Access Compliance Report Public Rights-of-Way (Curb Ramps)

Main Street: COUSTEAU_LN Cross Street: COUSTEAU_LN Location: E

ADA ID: RPRK211110140506 Ramp Type: Type 4 - Parallel Initial Pass/Fail: Fail Overall Compliance: No Severity Score: 2

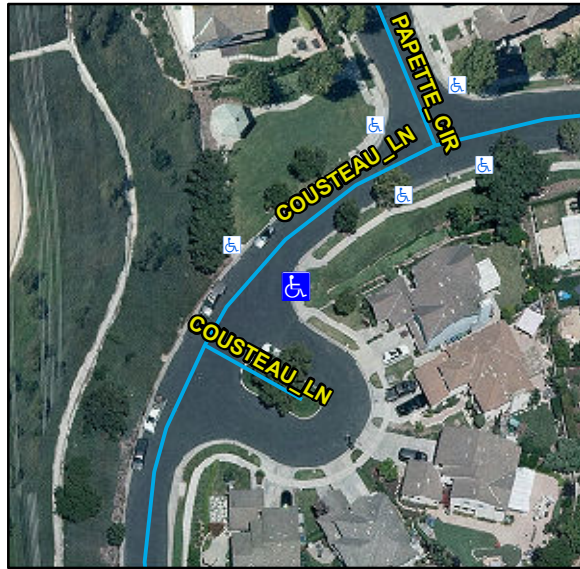
Compliance	Description	Data	Compliance	Description	Data
N/A	Ramp Length LT (in)	140	N/A	Ramp Length RT (in)	142
Yes	Ramp Width LT (in)	53	Yes	Ramp Width RT (in)	53
Yes	Ramp Run Slope LT (%)	4.2	Yes	Ramp Run Slope RT (%)	6.8
No	Ramp Cross Slope LT (%)	2.2	Yes	Ramp Cross Slope RT (%)	1.7
N/A	Landing Present	N/A	N/A	DWS Provided	N/A
N/A	Landing Length (in)	N/A	N/A	DWS Contrast	N/A
N/A	Landing Width (in)	N/A	N/A	DWS Length (in)	N/A
N/A	Landing Run Slope (%)	N/A	N/A	DWS Full Width	N/A
N/A	Landing Cross Slope (%)	N/A		DWS Offset Type	N/A
N/A	Landing Movement Obstructed?	N/A	N/A	DWS Offset Left (in)	N/A
	Landing Movement Type	N/A	N/A	DWS Offset Right (in)	N/A
N/A	Landing Shared	N/A			
N/A	Clear Space	Yes			
N/A	Clear Space To Crosswalk (in)	N/A			
N/A	Marked Crosswalk 1	No	N/A	Marked Crosswalk 2	No
	Crossing 1 Direction	NW		Crossing 2 Direction	SW
	Marked Crosswalk 1 Width (in)	N/A		Marked Crosswalk 2 Width (in)	N/A

N/A	Ramp Inside Crosswalk 1	N/A	N/A	Ramp Inside Crosswalk 2	N/A
	Crossing 1 Slope (%)	1.9		Crossing 2 Slope (%)	1.3
	Crossing 1 Cross Slope (%)	1.8		Crossing 2 Cross Slope (%)	0.3
N/A	Gutter Ponding	N/A	No	Curb Slope	9.3
Yes	Gutter Lip Height (in)	0		Road Run Slope (%)	0.3
N/A	Gutter Run Slope (%)	N/A		Road Cross Slope (%)	2.7
N/A	Gutter Cross Slope (%)	N/A	No	Perpendicular Joint Present	No
Yes	Overall Surface Condition	Acceptable			
	Cross Gutter Present?	No		Spandrel Present?	No
	Replace Cross Gutter?	N/A		Replace Spandrel?	N/A

Remove & Replace Curb Ramp With Two New Directional Ramps or Equivalent.

R304.2.2, R204.3, R304.5.3, STD 1115
